HCCSC Salamonie HVAC Replacement and Renovation

Project # 2024.0002
10-08-2024

ADDENDUM NO. 02

DEMOLITION - ROOF PLAN PHASE 1-3

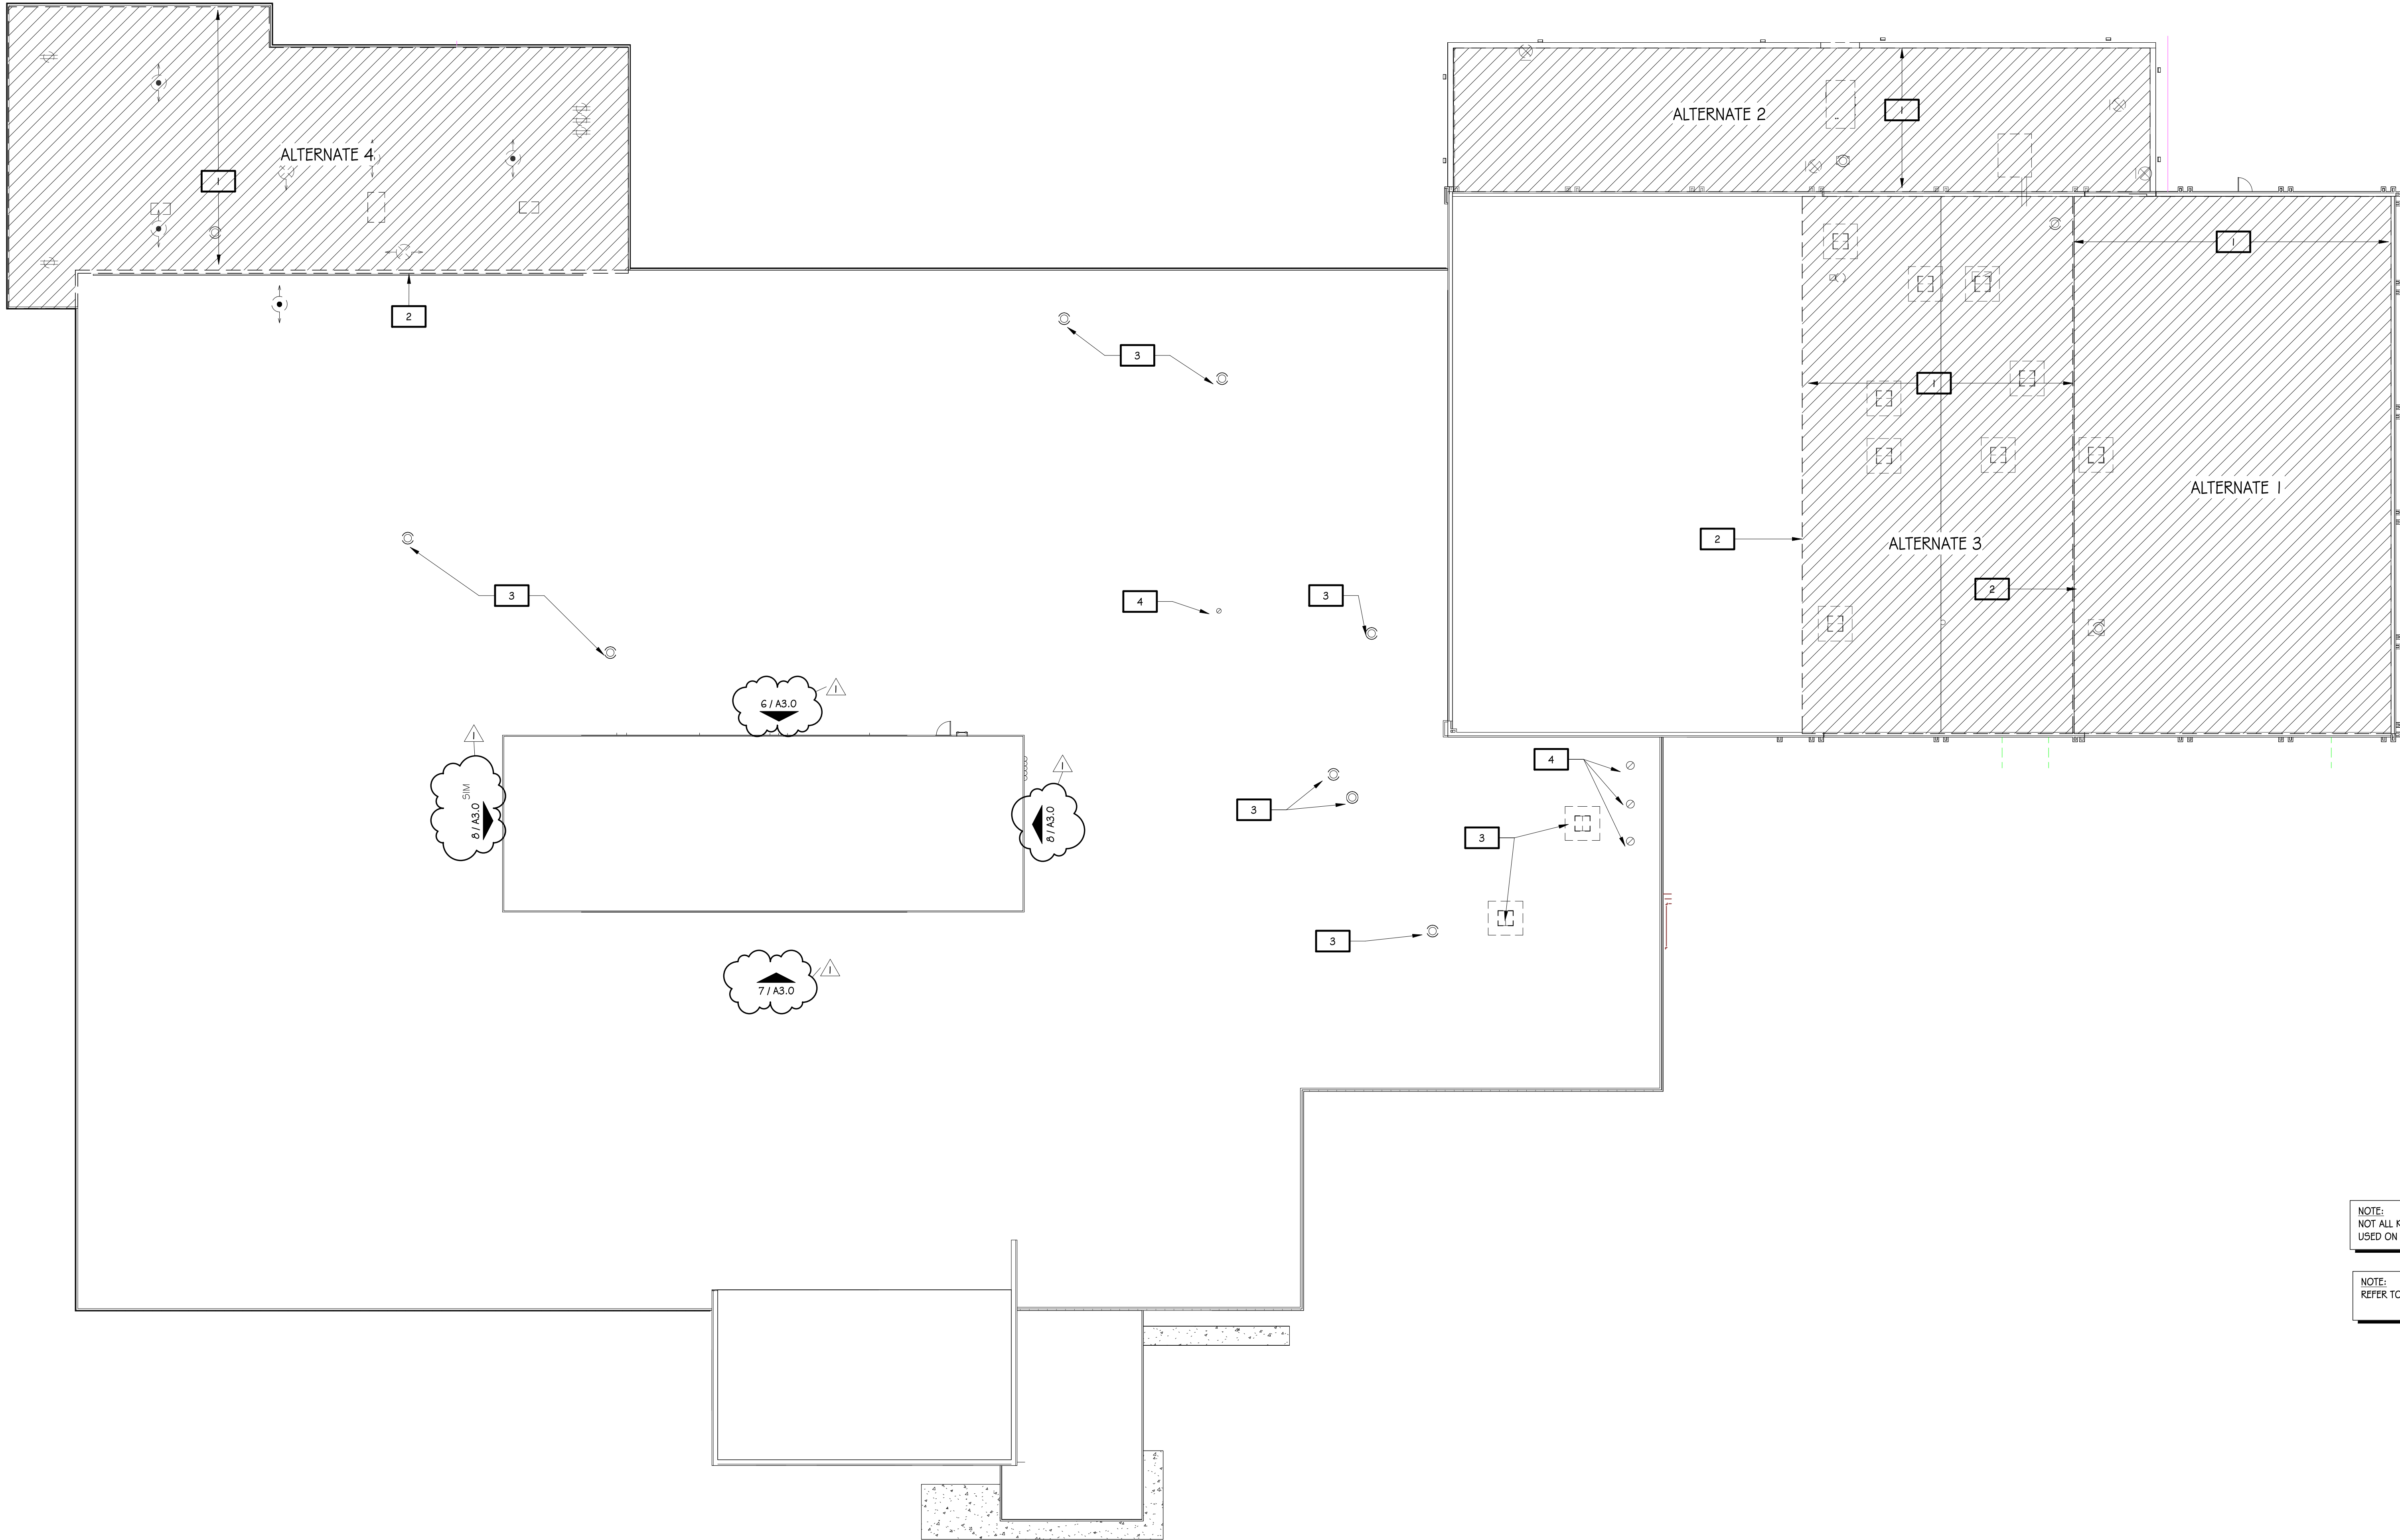
Item: A-2.5
Location: Drawings
Description: Delete original Drawing dated 9-24-2024 & replace Drawing with revision date 10-08-2024:

- D2.4 DEMOLITION ROOF PLAN – PHASES 1-3 ADD2

SHEET
A3.0

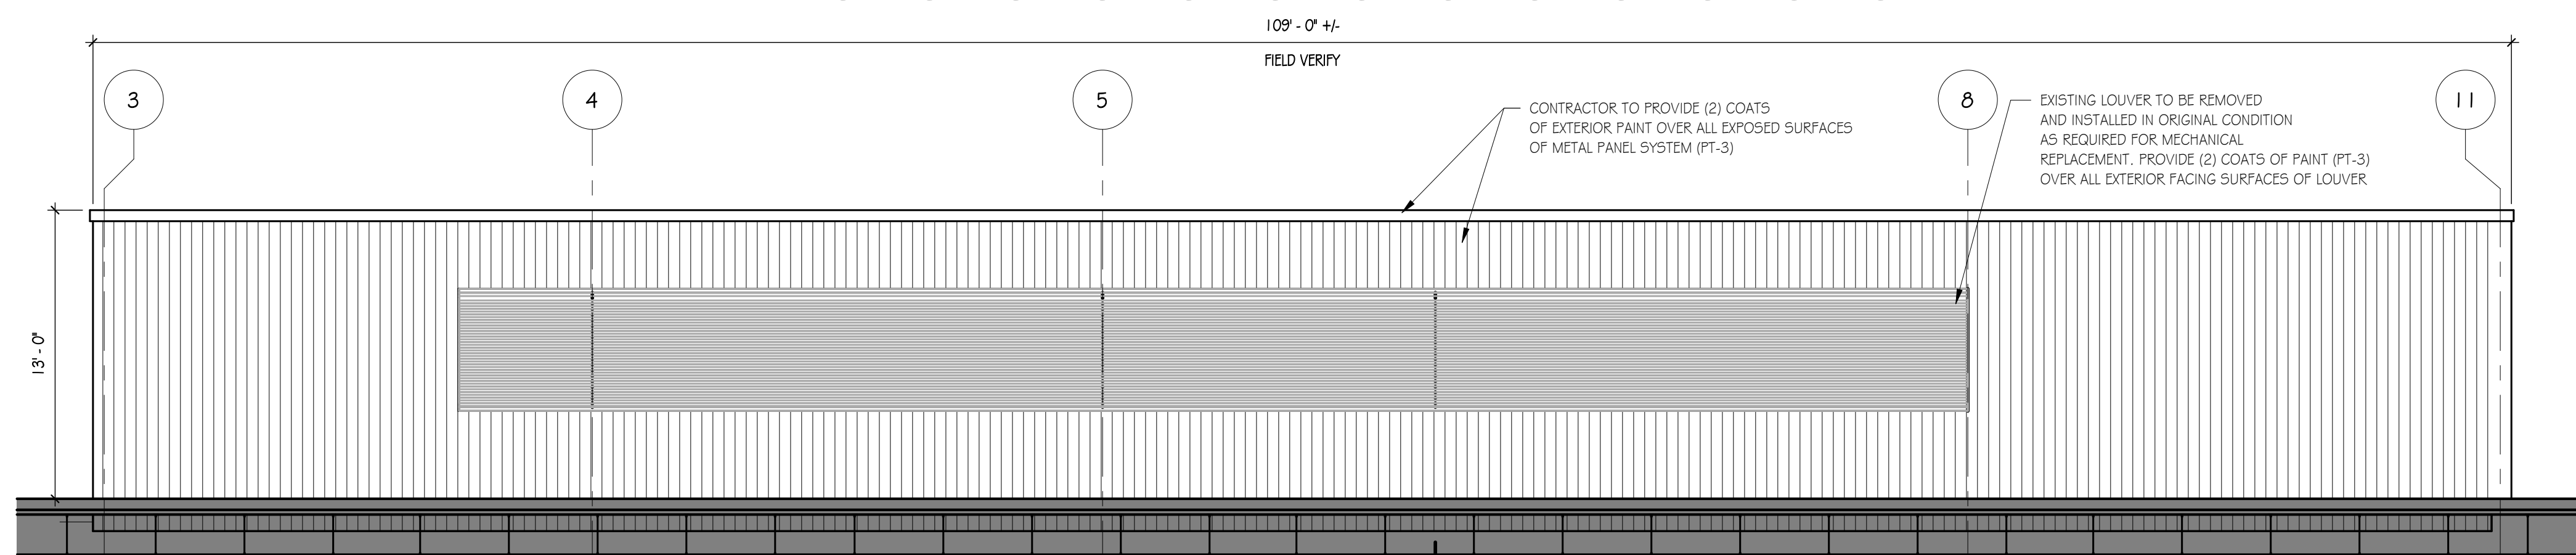
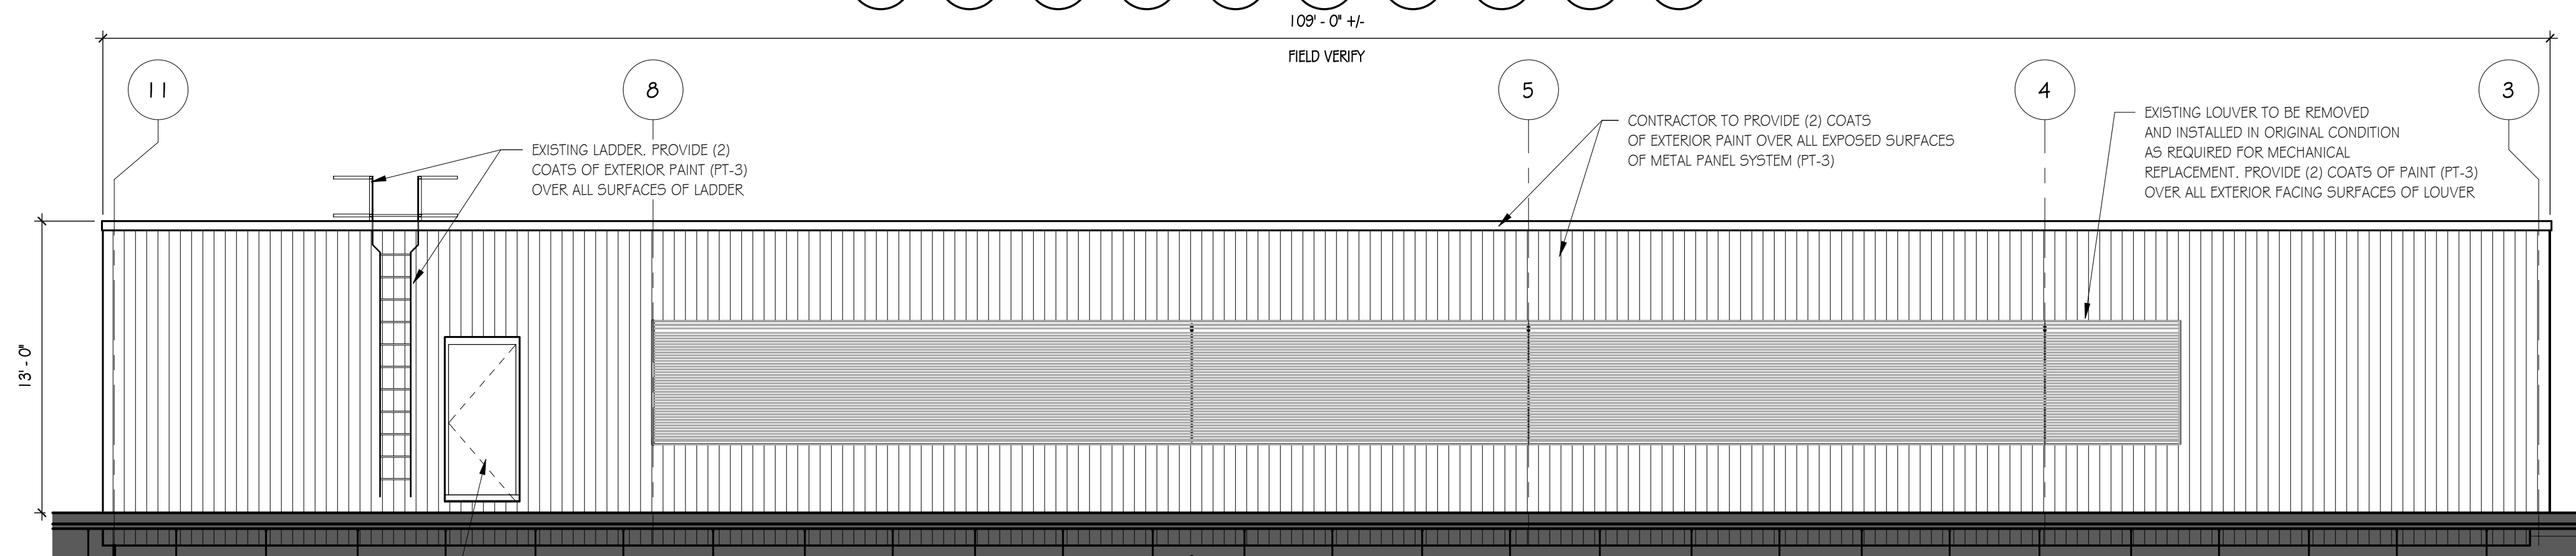
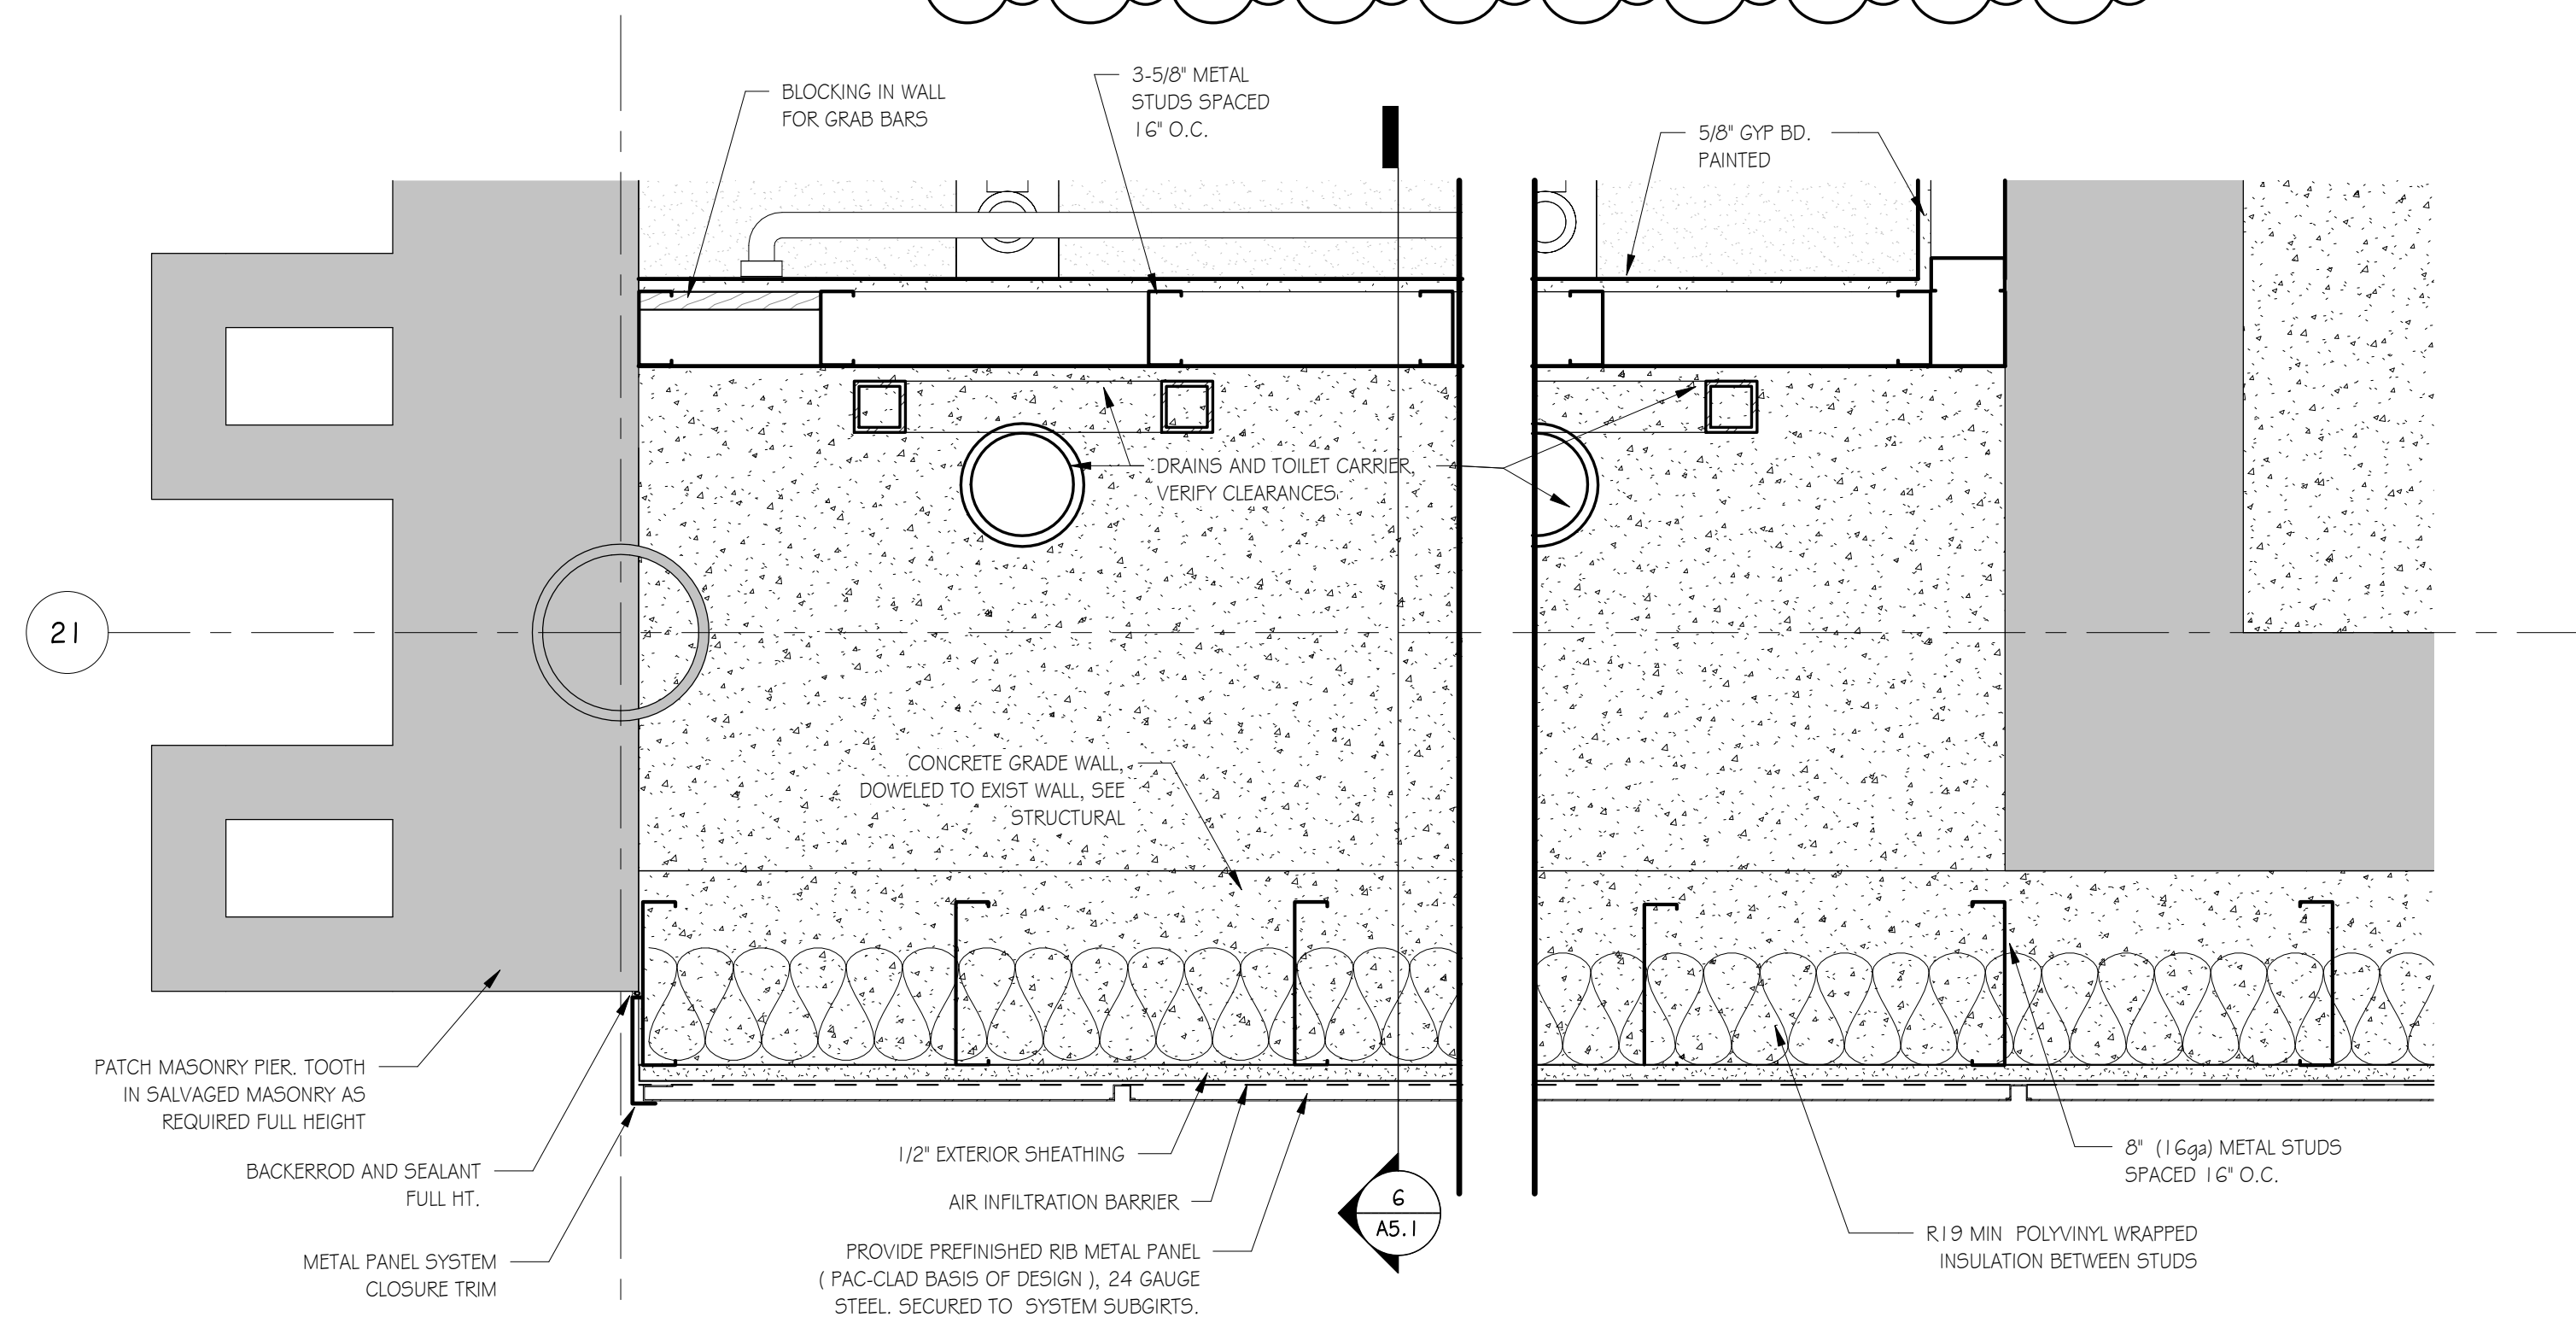
- Change Drawing Name from “A3.0 – ENLARGED PLANS AND DETAILS – ALTERNATES” to “A3.0 ENLARGED PLAN DETAILS AND ELEVATIONS ADD2”.
- Drawing Sheet A3.0, Add Penthouse Elevations, details 6, 7 & 8 with notes for Exterior Painting of Metal Siding system of Penthouse, Color PT-3.
- PT-3: See Section 090190.52, Architect to Select from Manufacturer’s standard range.
